INSTRUCTIONS TO CONVERT TELETYPEWRITER EQUIPMENT FROM
7.42 UNIT CODE TO 7.00 UNIT CODE WITH AND WITHOUT SYNCHRON-
OUS PULSED TRANSMISSION AND 45.5, 50, 75 BAUD SPEEDS

NAVSHIPS 981560(B)

FIELD CHANGE BULLETIN

FIGURE 1. WIRING CHANGES FOR POWER DISTRIBUTION PANEL SB-154/UG

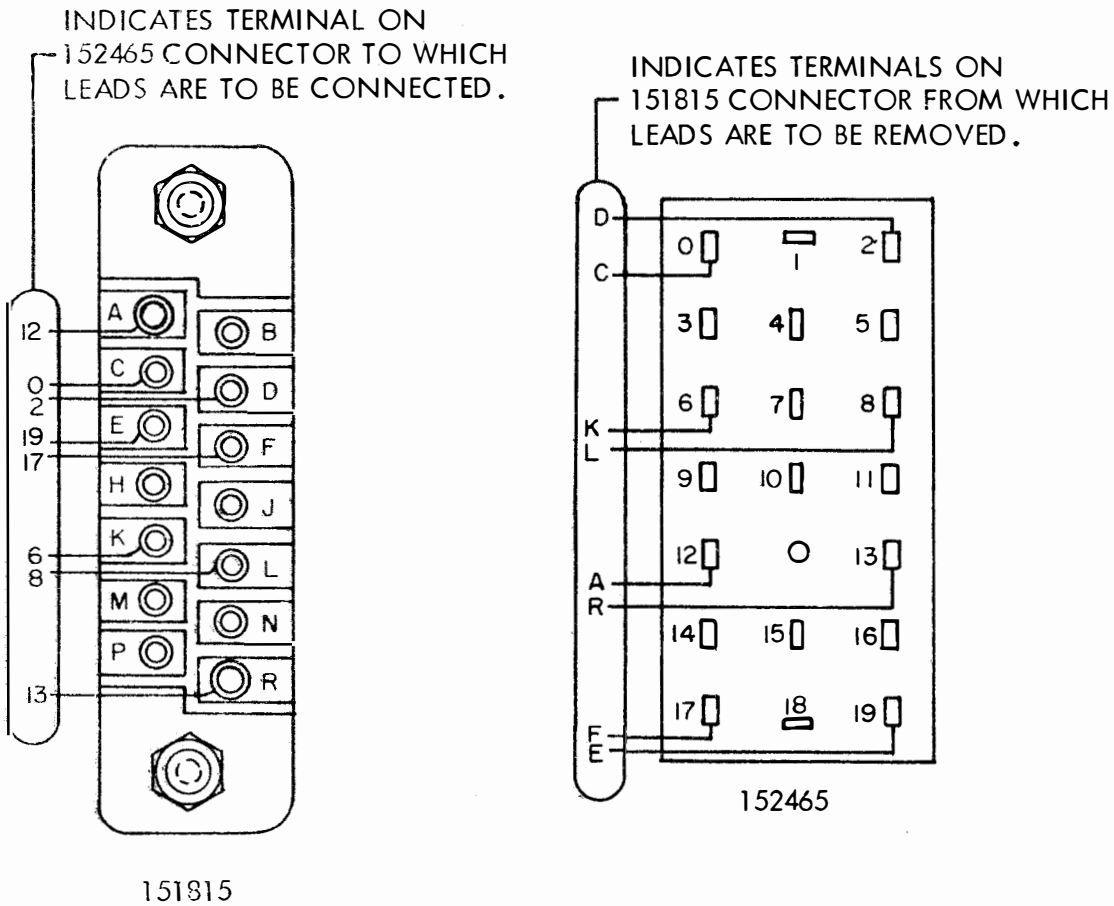
(6) For electrical service unit not equipped with the 152465 connector wire in accordance with Figure 1.

Figure 2

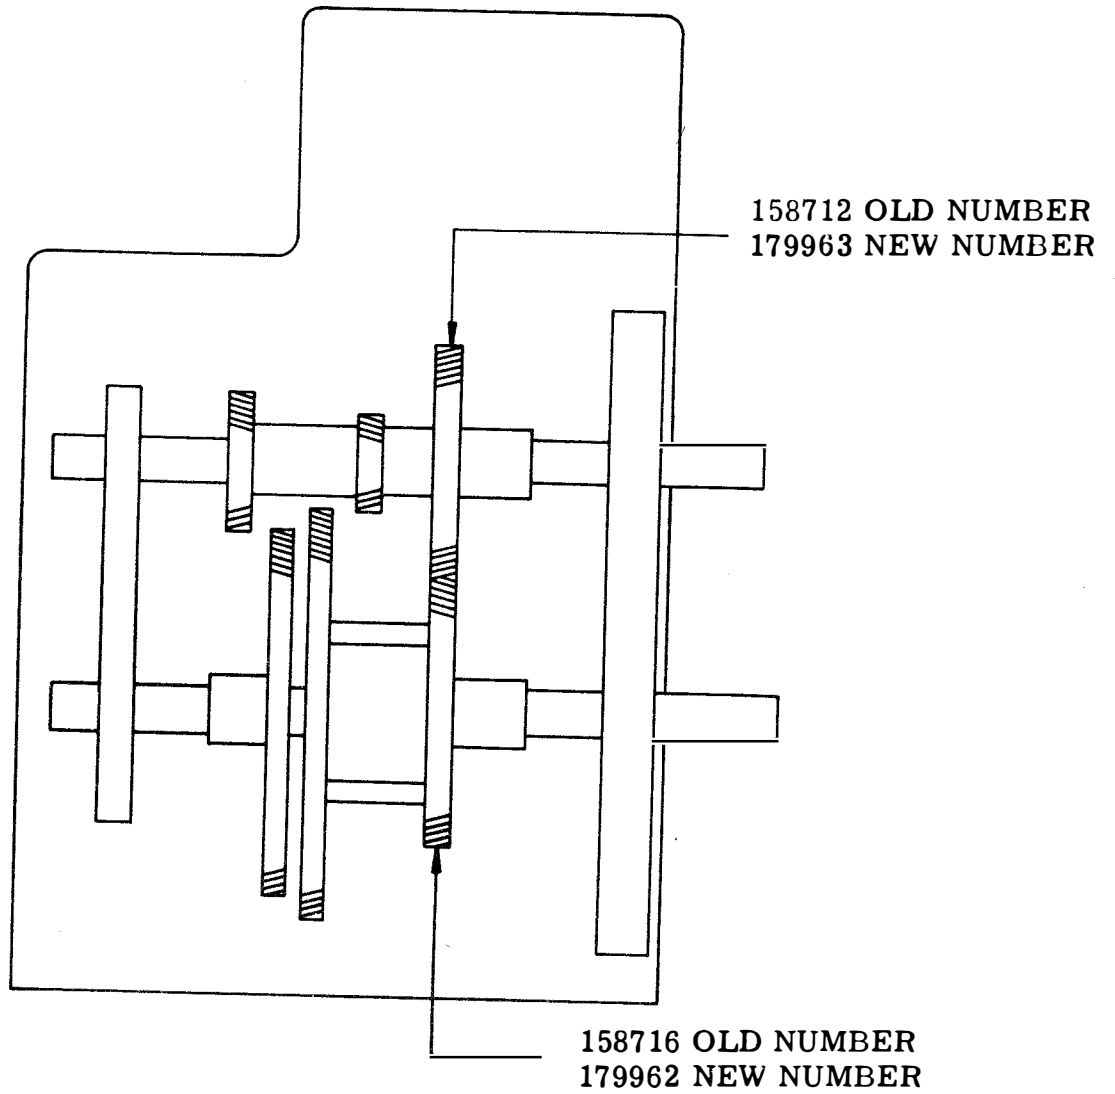
(b) For the 305674 modification kit, replace the following parts of the 178869 gear shift bracket assembly; 158712 gear, 158716 gear and 178884 gear shift assembly with 179963 gear, 179962 gear and 192679 gear shift assembly respectively. Refer to Figure 2 for location of parts.
